Application No. 10/565,291  
Amdt. Dated: January 15, 2008  
Reply to Office Action of: October 23, 2007

**Amendments to the Drawings**

### **Remarks/Arguments**

FIG 5

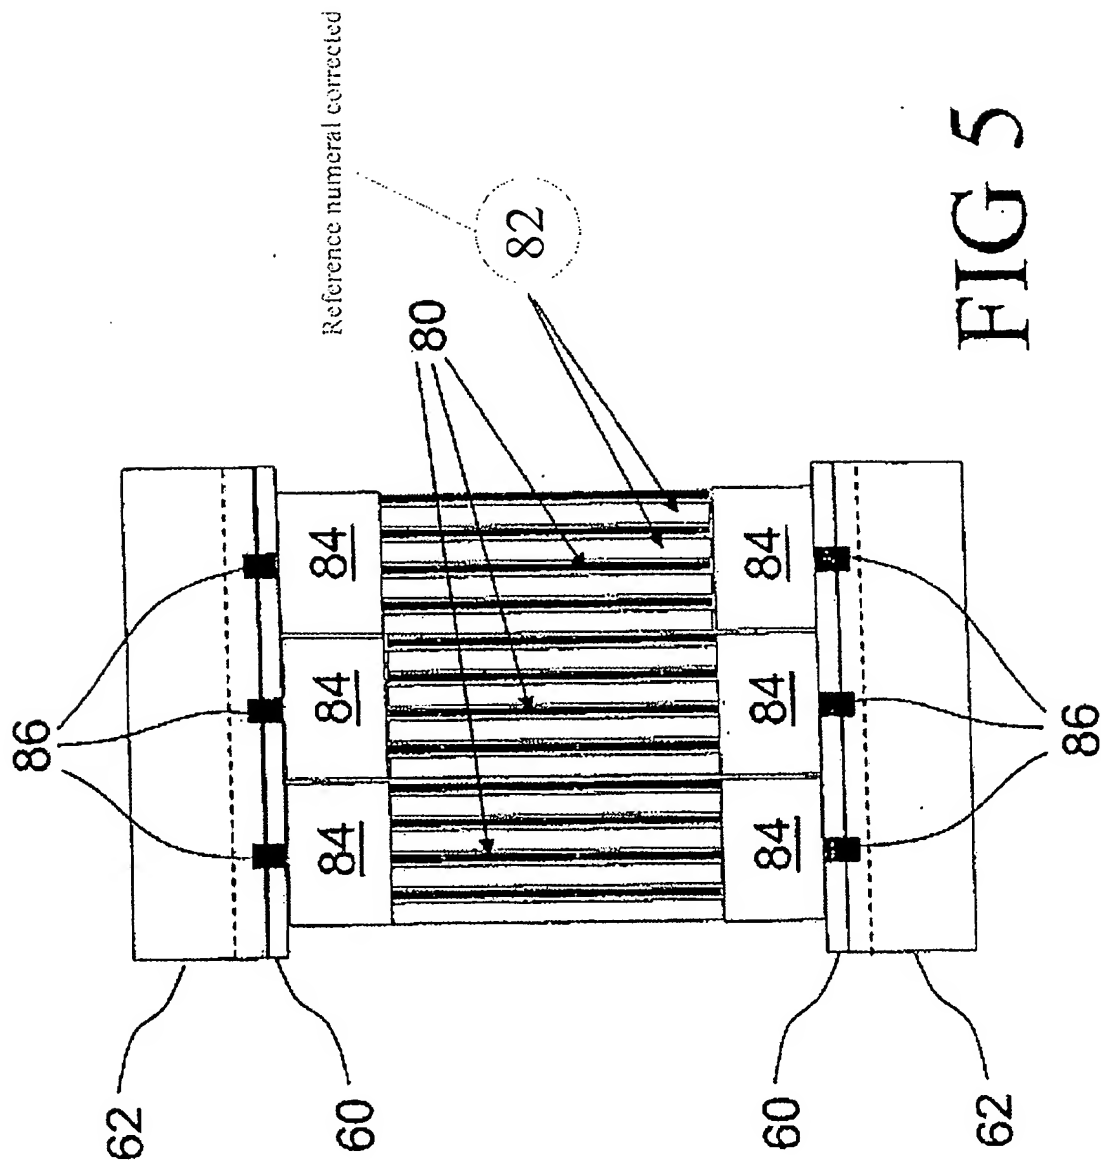
Fig. 5 is objected to because reference number 82 is split in the middle. This objection should be withdrawn because the reference numeral has been amended to remove the split.

The drawings stand objected to as failing to comply with 37 CFR §1.84(p)(5) because they do not include reference numerals 104 and 132, which are mentioned in the specification. This objection should be withdrawn as reference numeral 104 has been added to Fig. 7, and reference numeral 132 has been removed from the specification.

The attached sheets of drawings include changes to Figs. 5, 7 and 9. These sheets, which respectively include Figs. 5, 7 and 9, replace the original sheets including Figs. 5, 7 and 9. In Fig 5, the reference numeral 82 has been corrected, in Fig. 7, the reference numeral 104 has been added, and in Fig. 9 the reference numeral 106 has been change to 160.

Reference numeral 104  
has been added
